SUBJECT: Responds to Item III-1, NRC question re design & const for systematic evaluation program seismic review. Response deals w/details of block walls throughout plant. Two oversized drawings encl.

Subject: Systematic Evaluation Program Seismic Review
R.E. Ginna Nuclear Power Plant
Docket No. 50-244

Response for NRC Question III-1

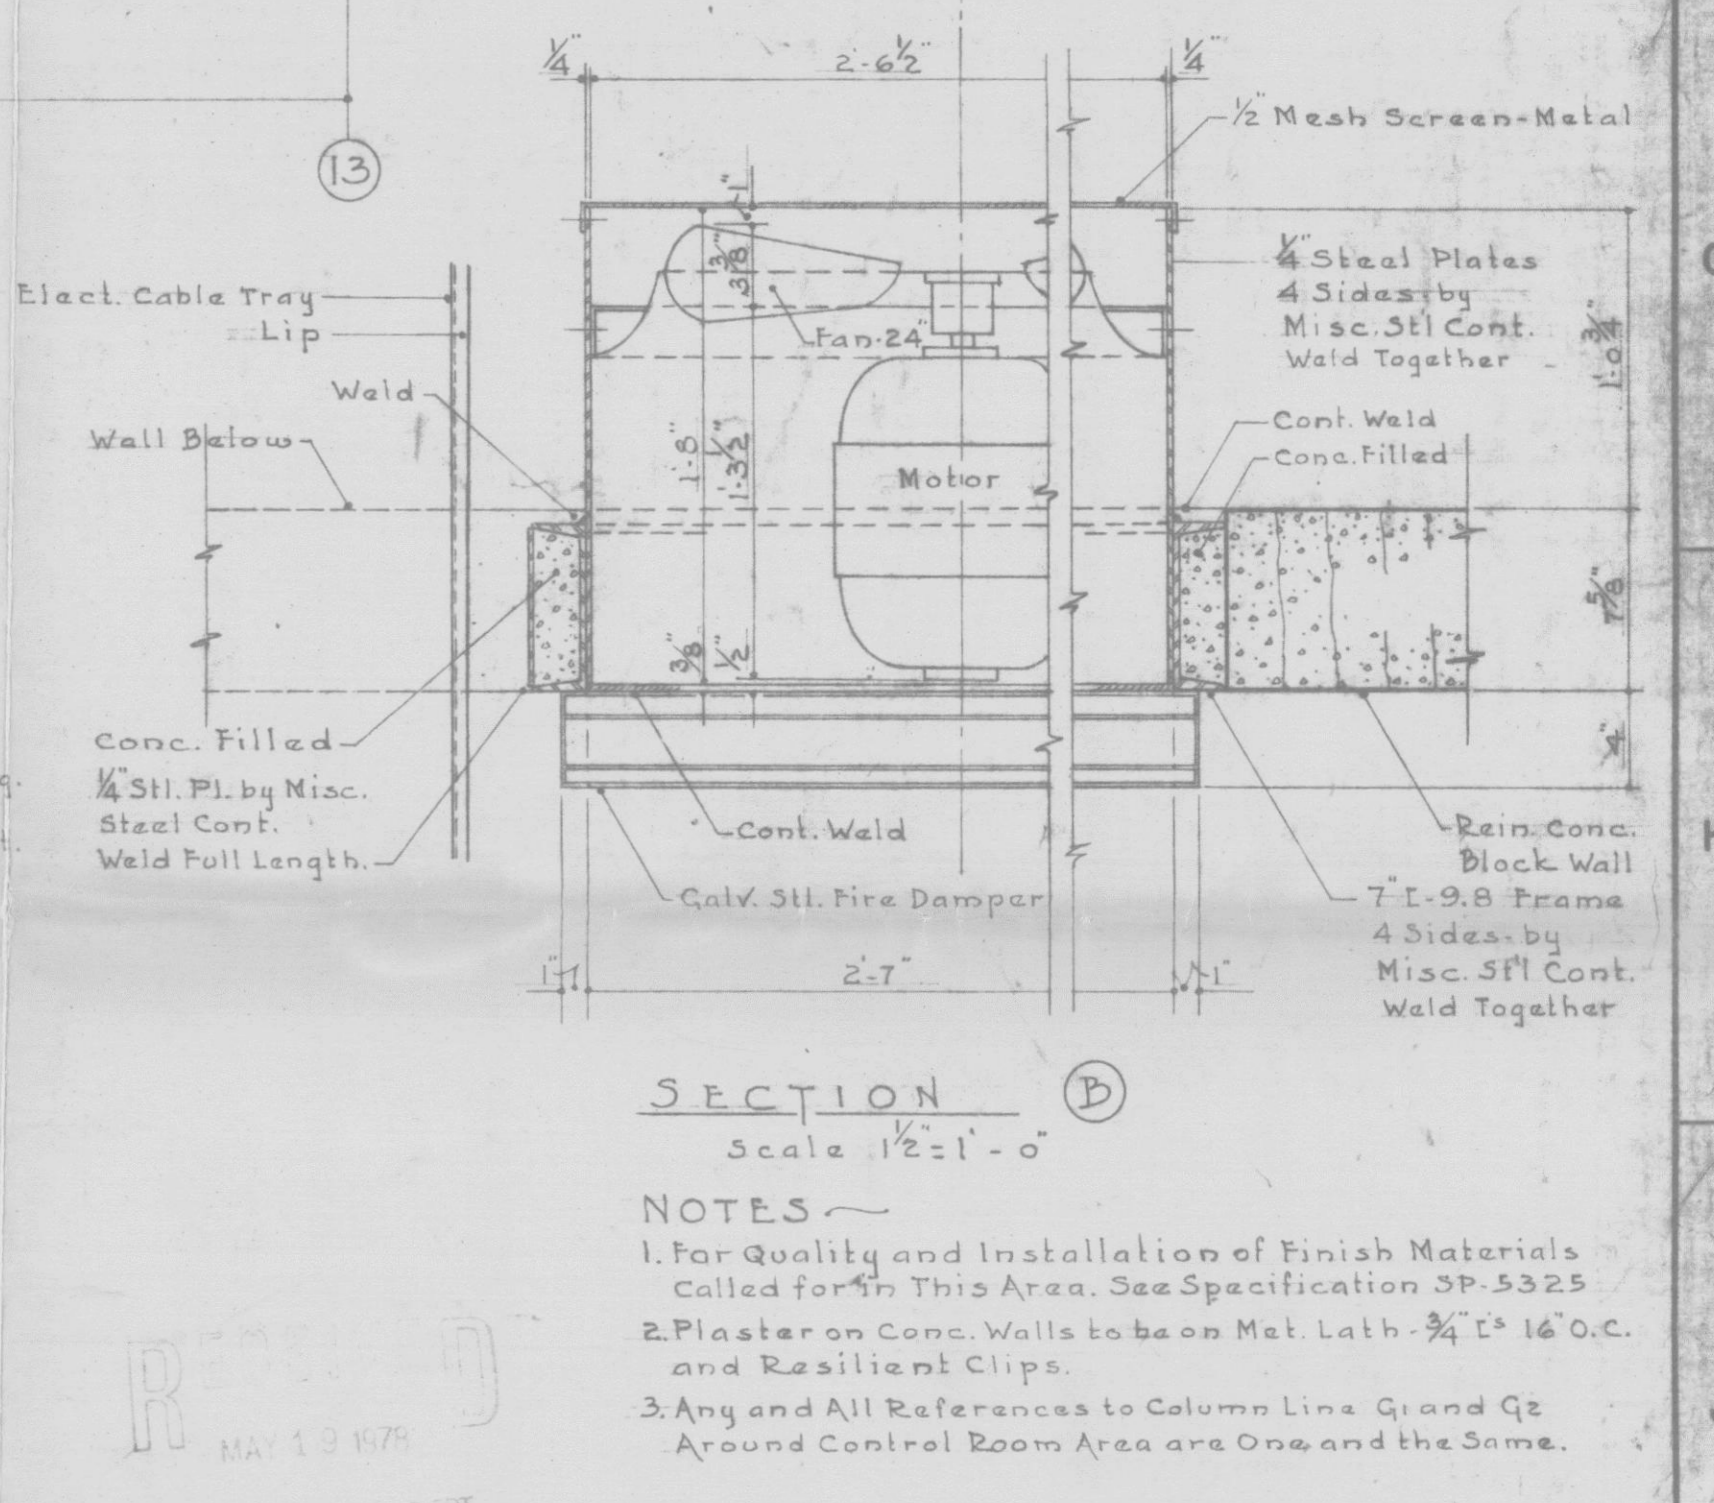
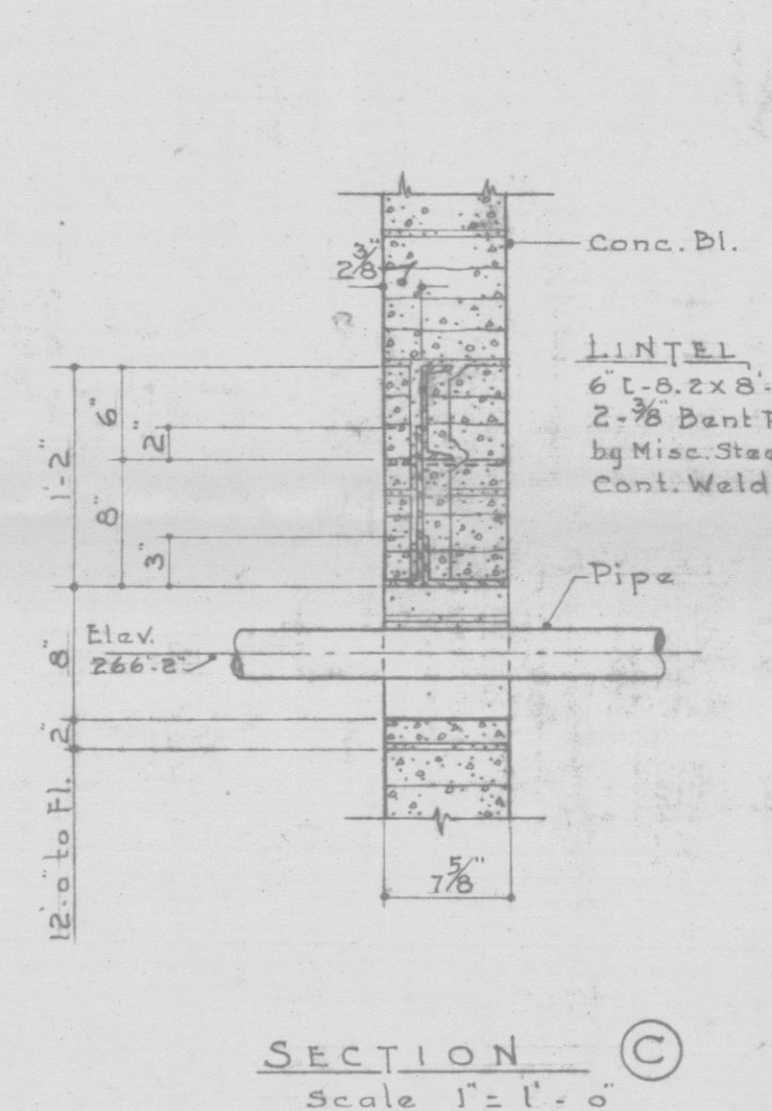
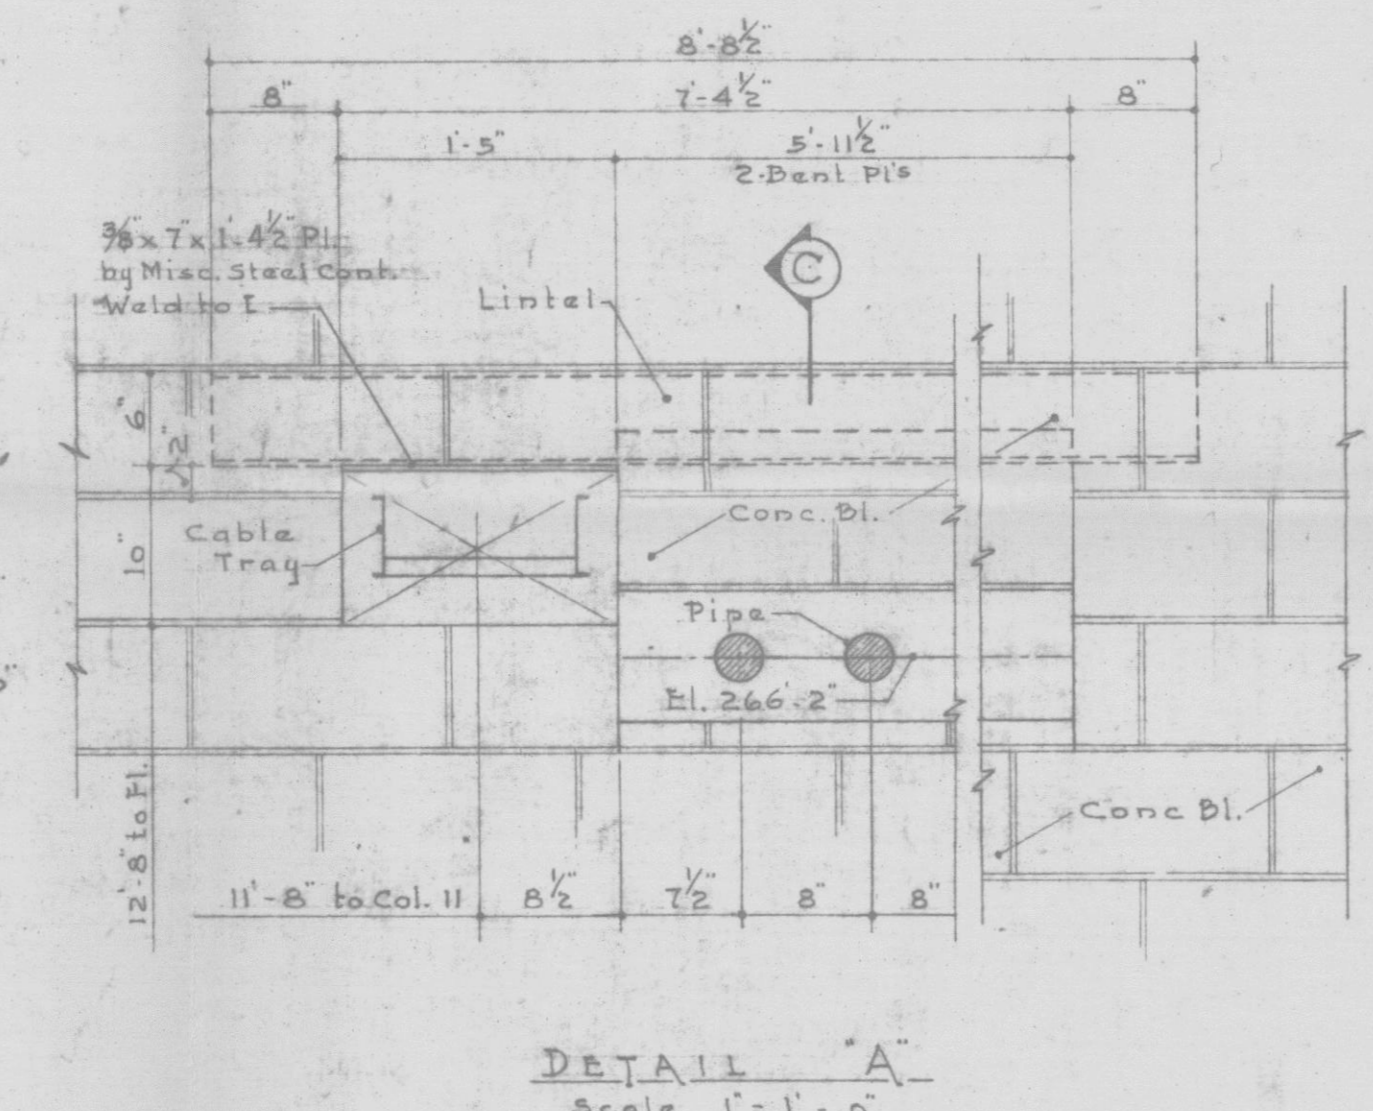
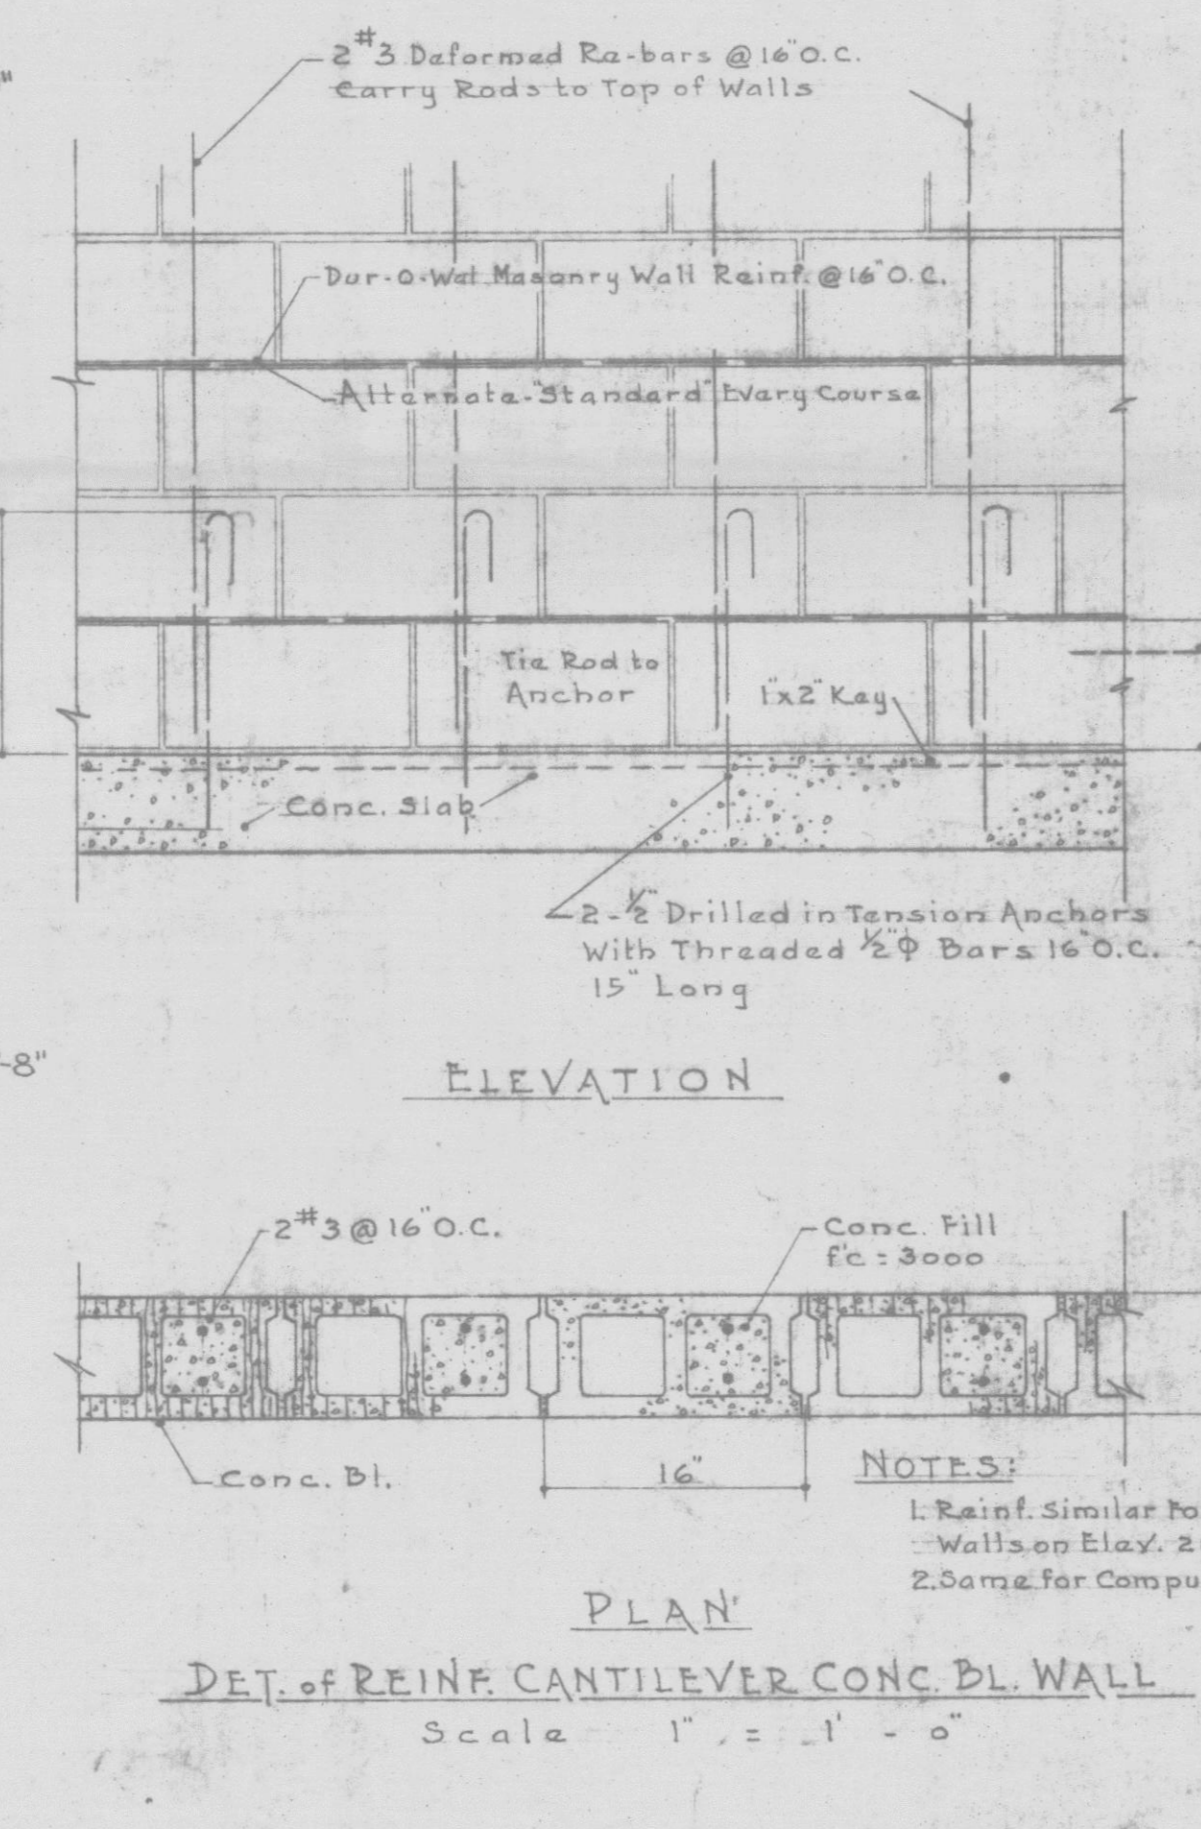
This letter supplements our earlier letters in responding to questions raised by the NRC Seismic Review Team on the design and construction of Ginna Station. Item III-1 identified in our letter of May 22, 1979 dealt with a request for information on details of the block walls throughout the plant. The attachment to this letter and the enclosed drawings respond to that request.

Reinforced concrete block walls are used in the Control Building and for the freight elevator shaft inside the Containment Building. Details of the reinforcement in the block walls are presented on drawings D-105-011 and D-105-012. Reinforcement details for the elevator shaft are the same as those presented for the Battery Room walls in the Control Building. All other block walls throughout the plant have reinforcement provided in the horizontal layers as follows:

1. Horizontal bed reinforcement is Dur-O-Wal standard truss design or Hohmann & Barnard, Inc. Trus-Mesh, of width two inches less than the nominal thickness of the wall. Bed reinforcing is laid in alternate courses, splice lapped six inches, cut and bent at corners. Over openings reinforcement is laid in the first and second bed joint and extends 24 inches on either side.
2. At junctions of partitions and walls, ties $1\frac{1}{2}$ " x $\frac{1}{4}$ " x 8" flats with two inch right angle bends at either end are inserted at 24 inch centers.
3. At steel columns, wall anchors 2" x $\frac{1}{4}$ " flats with two inch right angle bends at either end are provided at 24 inch centers. Ties are extended approximately to the center of the block wall.

Concrete masonry blocks are hollow units, conforming to ASTM C90-66T, Grade G-II and mortar conforming to ASTM C270-64T, Type N.
